CITY OF ST. PETERSBURG, FLORIDA
PLANNING AND DEVELOPMENT SERVICES DEPARTMENT
URBAN PLANNING AND HISTORIC PRESERVATION DIVISION

STAFF REPORT

Community Planning and Preservation Commission Certificate of Appropriateness and Variance Request

AGENDA ITEM: CITY FILE NO.: COA 20-90200098/Variance 20-54000060

Figure 3: Applicant photograph of subject property (left), location of proposed garage addition, and adjacent detached garage facing 23rd Ave. NE

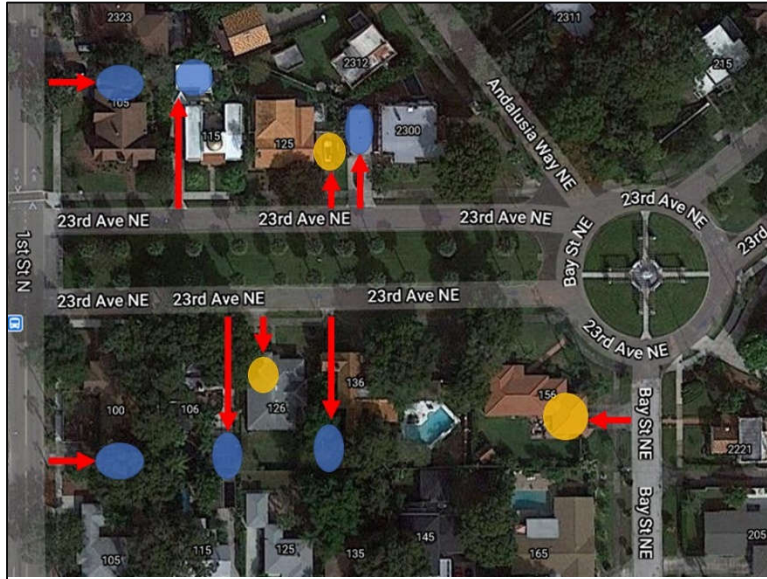
Because of the lack of alley access, driveways and garages on the subject block face 23rd Ave. NE. This stretch of road features a prominent grassy boulevard which is a character-defining feature to Granada Terrace. Contributing properties' garages throughout the district tend to be detached from, and located behind, the primary residence. Some properties feature semi-detached garages which are conjoined to their primary residences by hyphens or breezeways but are still visually distinct from the building forms of the primary resources on their parcels.

Because of its location on the pie-shaped corner parcel at the intersection of 23rd Ave. NE and Andalusia Way NE, the contributing property directly east of the subject property (2300 Andalusia Way NE) has a south side elevation that aligns with the façade of the subject property. Its detached rear garage, which is accessed via 23rd Ave. NE, is therefore directly adjacent to the location of the proposed garage addition.

Driveway and garage access to properties on the subject block is illustrated in Figure 4. The proposed garage addition will not introduce a new curb cut or street-facing driveway into the district.

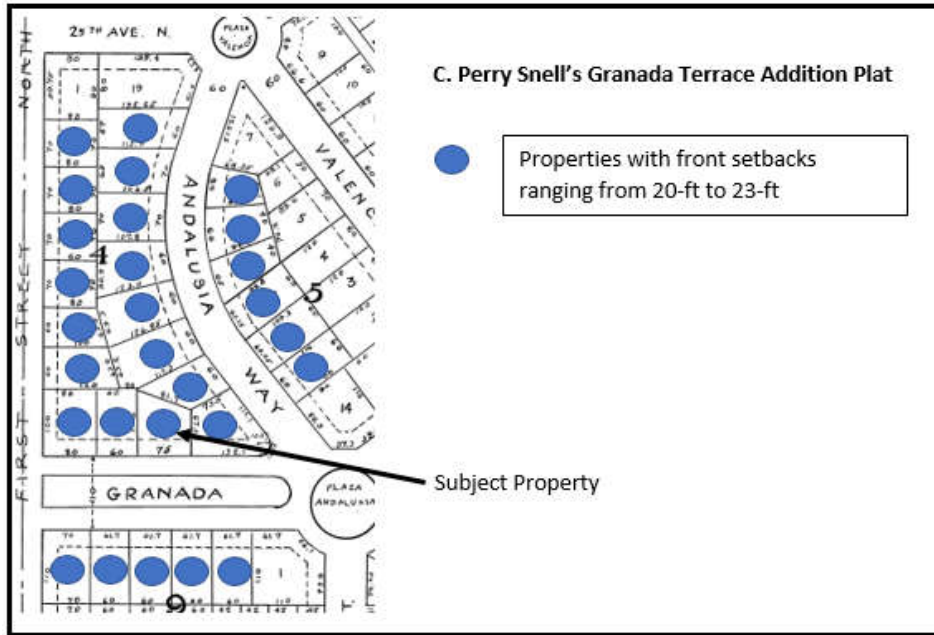
As indicated above, the existing house and front setbacks were approved by the Board of Adjustment in 1959. Section 16.20.010.10. of the City Code address setbacks and FAR within established neighborhood patterns. This Section recognizes that the existing characteristics of minimum yard setbacks in existing neighborhoods may differ from the zoning district requirements. In these cases, approvals are allowed when front setbacks are based on predominant building setbacks established in the block in which the development is proposed. The predominant building setbacks established in the block are provided in the table below. This Section of the Code also defines predominant as equal to or greater than 50 percent. As identified in the table below, 100% of the properties on the block have setbacks ranging from 19.5-ft to 21-ft:

<u>ADDRESS</u>	<u>FRONT SETBACK</u>
105 23 rd Ave. NE	20 ft
115 23 rd Ave. NE	21 ft (19 ft porch setback)
125 23 rd Ave. NE	19.5 ft (Subject property)
100 23 rd Ave. NE	20 ft
106 23 rd Ave. NE	21 ft
126 23 rd Ave. NE	20 ft
136 23 rd Ave. NE	20.5 ft

All lots on this block of 23rd Avenue NE and along Andalusia Way NE have front setbacks ranging between 20-ft and 23-ft as shown below.

However, the Code Section 16.20.010.11 *Building and Site Design* requires that garage doors facing the primary street be at least 10 feet behind the front façade line of the principal structure. With the established front yard setback of 19.5 feet, this would require a garage setback of an additional 10 feet.

When weighing these competing factors, Staff recommends that the depth of the garage be reduced to provide a 4.5-foot setback (5.5-foot variance to the front yard setback from 29.5-feet to 24-feet). Staff finds that the reasons set forth in the variance application justify the granting of the side yard variance request of 3-feet due to the location of the neighbor's garage adjacent to the property.

SAMUEL RESIDENCE - GARAGE ADDITION

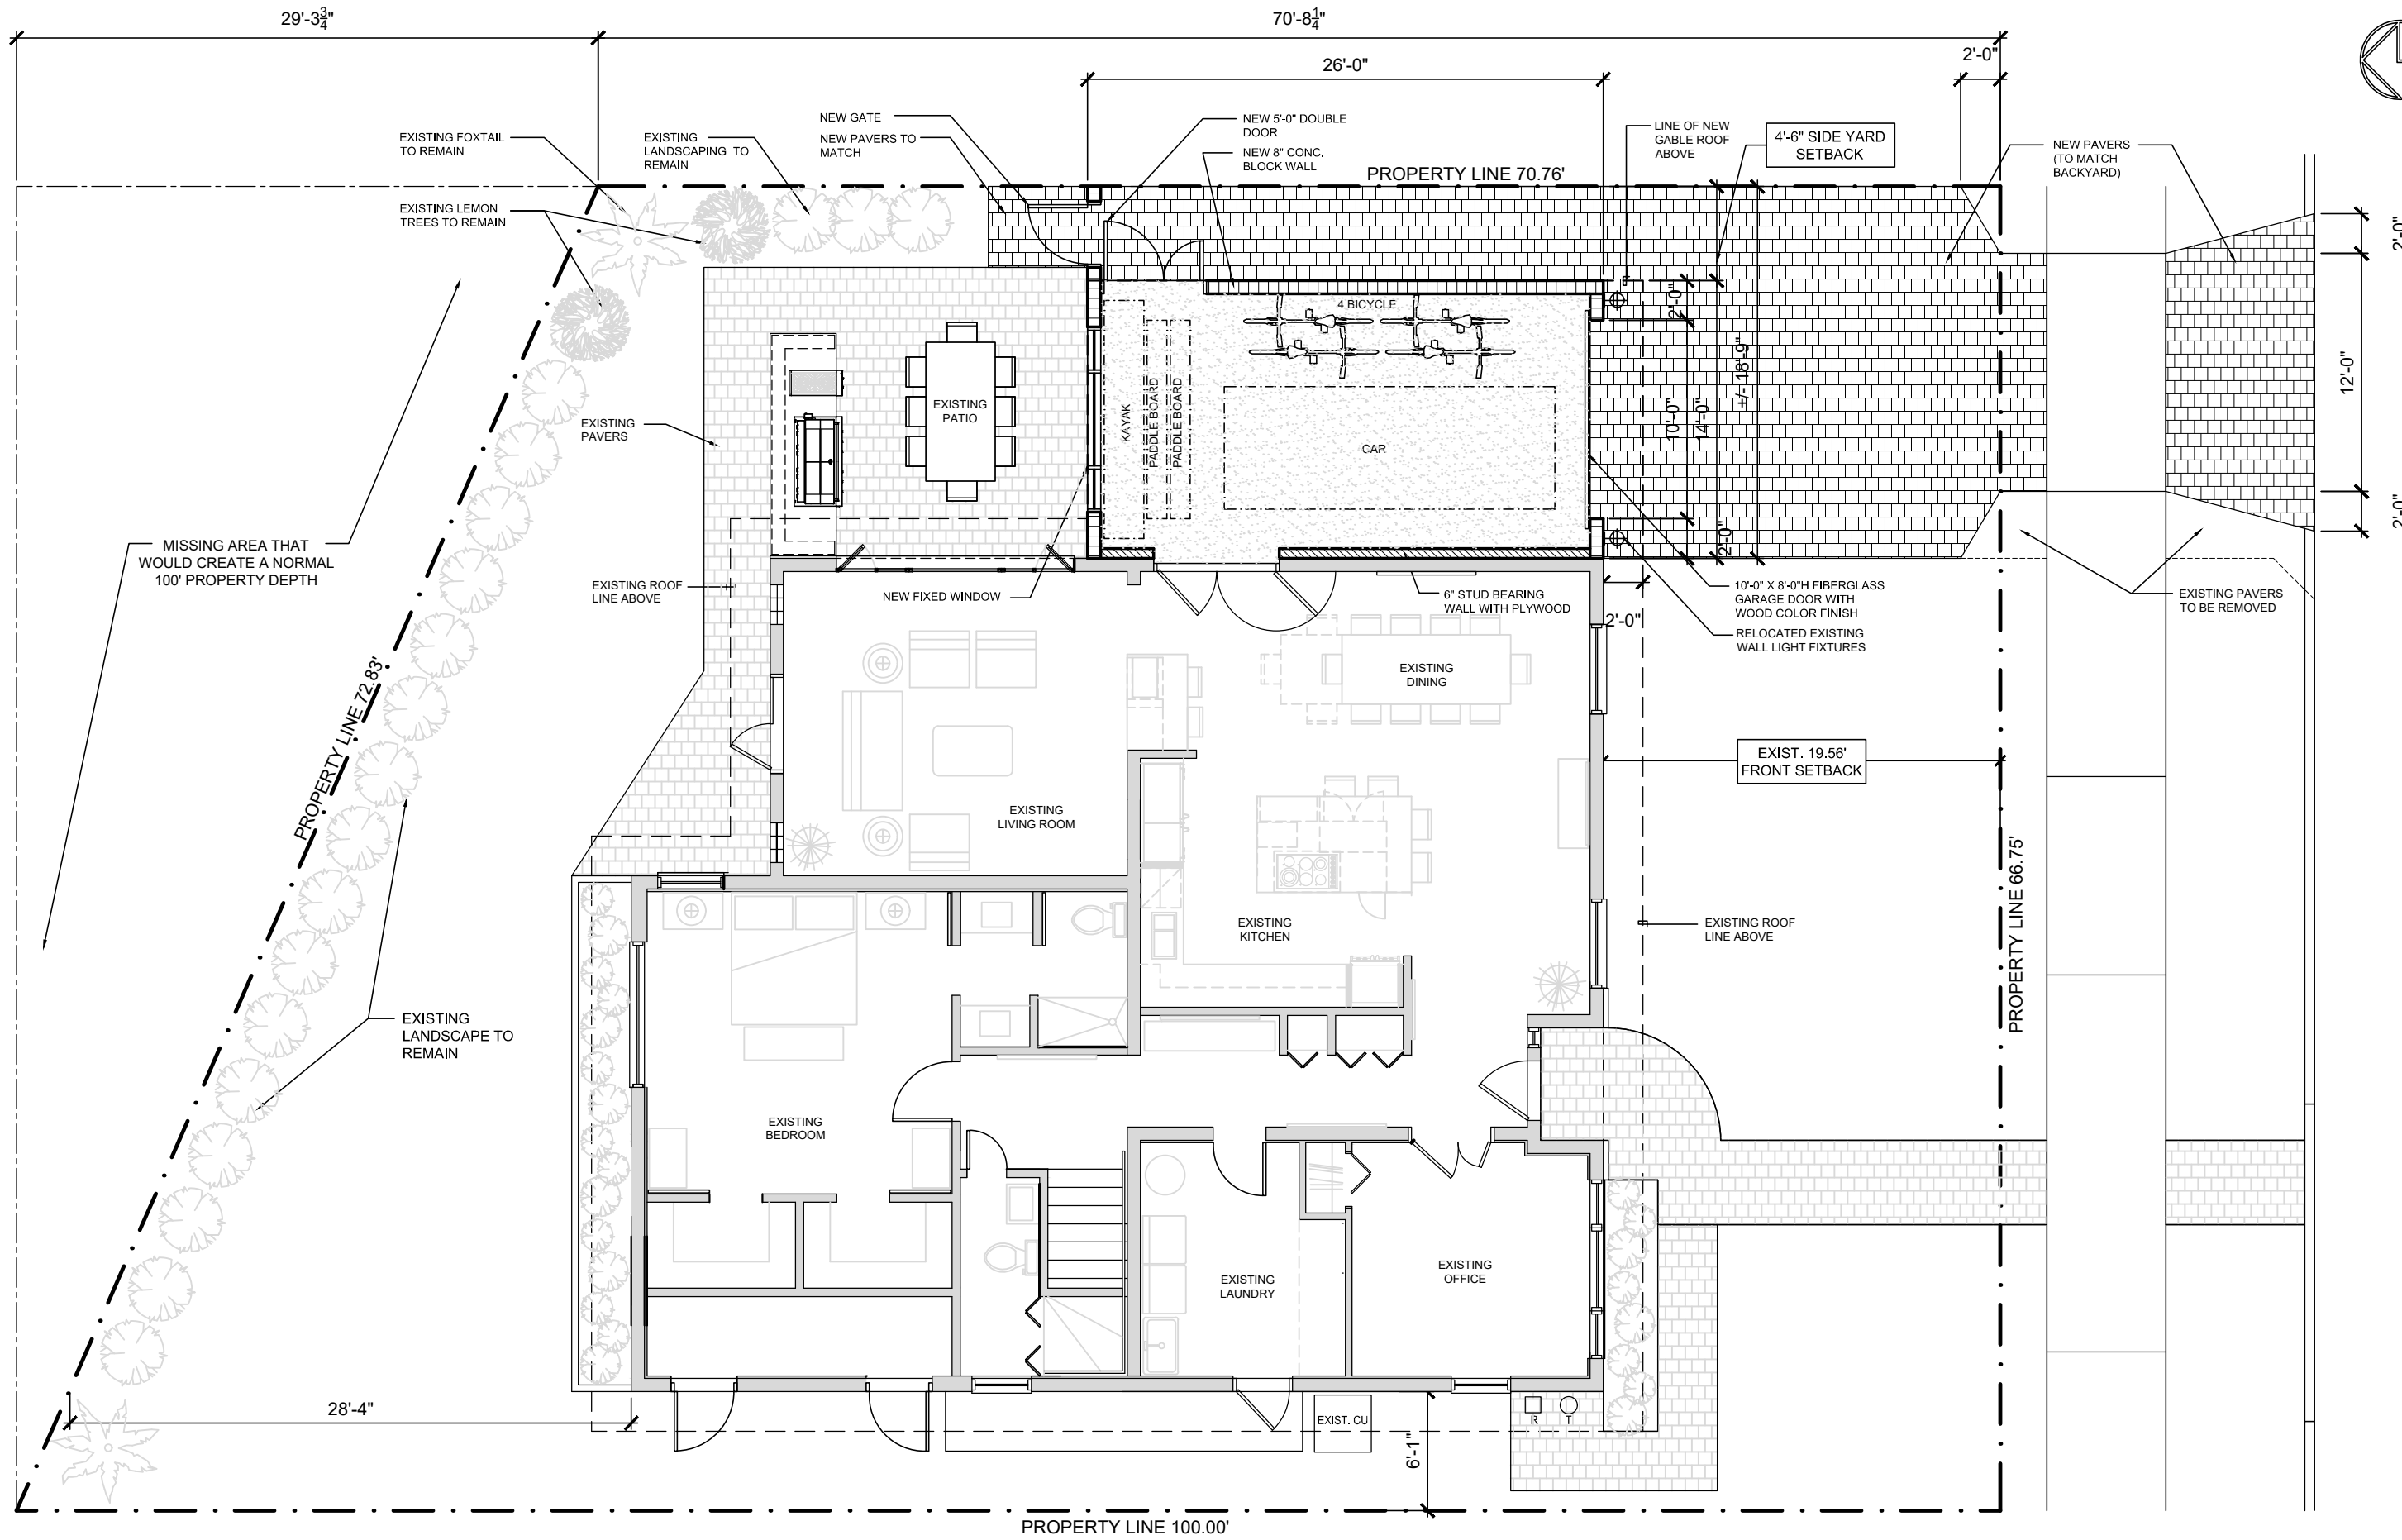
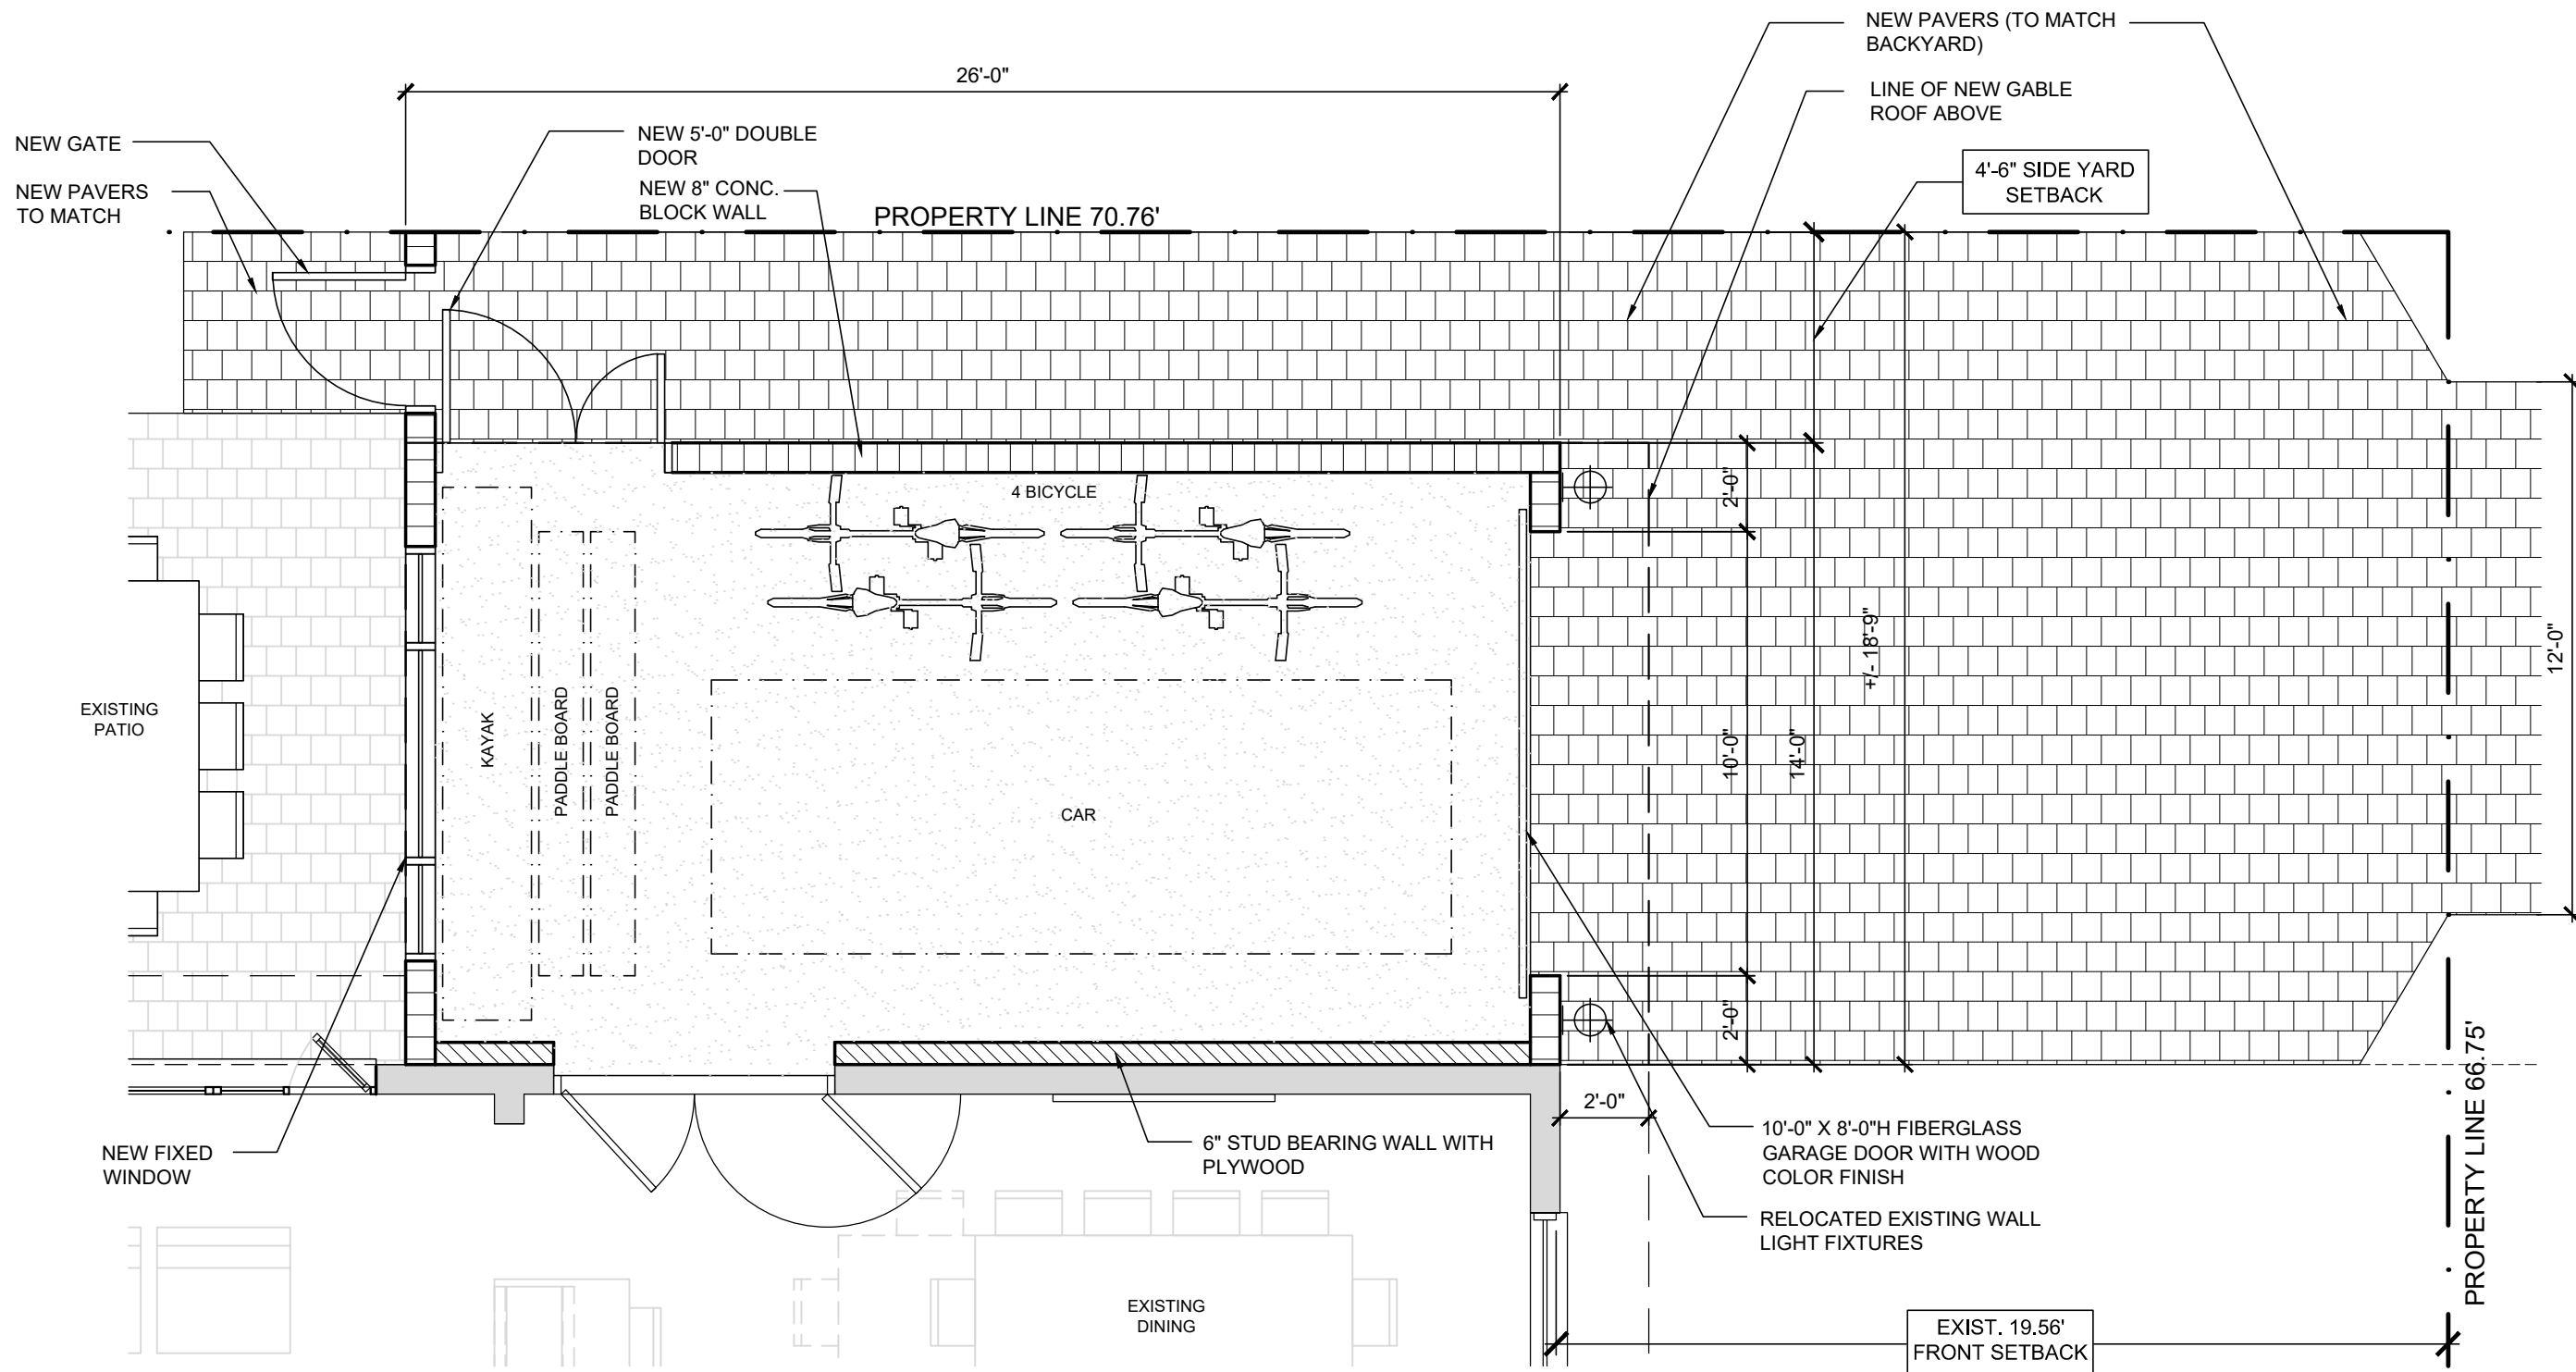
The proposed front-gabled roof of the garage addition will be slightly higher than the property's original roofline, which is not recommended. However, the applicant has decreased this height significantly from the original proposal in

Consistent with the Planning and Zoning recommendations and public comment, staff recommends that a garage addition at the subject property should be set back from the existing façade. This would accomplish the goals of adding articulation to the massing, as well as adhering to the hierarchy in which garages are visually subordinate to primary residences.

Staff has suggested that creating a small degree of articulation between the existing residence and proposed garage addition would create a more harmonious appearance than the extension of a straight façade line. Due to space constraints created by the irregular shape of the parcel and existing fenestration, the applicant has stated that a recessed garage is not possible in this location.

Generally consistent After considering staff feedback, the applicant lowered the proposed front gable's pitch to be lower than the adjacent detached garage at 13 feet, 8 inches. Ideally the pitch of the roof's addition should match that of the original

Staff does have concerns about the visual horizontality that will be created by the addition's creation of an unbroken façade line.

Inconsistent As noted above, the broad horizontal massing of the subject property is already fairly out of context for the subject district, and the proposal would serve to increase this impact by creating a façade with a total width of approximately 56 feet.

Generally consistent The proposed picture window at rear will not be visible from right of way. The plans show a fixed window approximately 10 feet wide at the rear of the addition, but information was not provided regarding its height or vertical placement. The proposed single-car panel garage door is similar to that found on other non-contributing resources and as an alteration on contributing resources.

Inconsistent The proposed flatness of the façade will enhance an existing incompatibility within the subject district.

Inconsistent The proposed roofline

Consistent A new gate is proposed in the side setback. Information on its material or design is not included but it should be wood or metal to comply with St. Petersburg's Design Guidelines for Historic Properties.

Inconsistent Proposed increases an existing inconsistency by extending the subject property's façade to create an even wider flush, horizontal plane. Staff suggests that a setback between the existing façade and proposed garage addition will mitigate the expansion's visual impact.

Based on a determination of general consistency with Chapter 16, City Code of Ordinances, staff recommends that the Community Planning and Preservation Commission **APPROVE WITH CONDITIONS** the Certificate of Appropriateness request for the addition to the property at 125 23rd Ave. NE subject to the following conditions:

1. The garage addition shall be set back between 2 and 5 feet from the primary façade line of the residence;
2. The roof form of the addition shall feature a pitch compatible with the roof forms at the primary residence. The revised roof form is to be approved administratively with Commission review upon request of staff or the applicant;

3. The proposed gate shall be constructed of wood or metal material;
4. Details of the proposed windows and door at the rear and side of the garage addition shall be reviewed and approved administratively. The windows shall be recessed in the wall plane approximately 2- to 3 inches and feature a sill to provide consistency with windows at the primary residence;
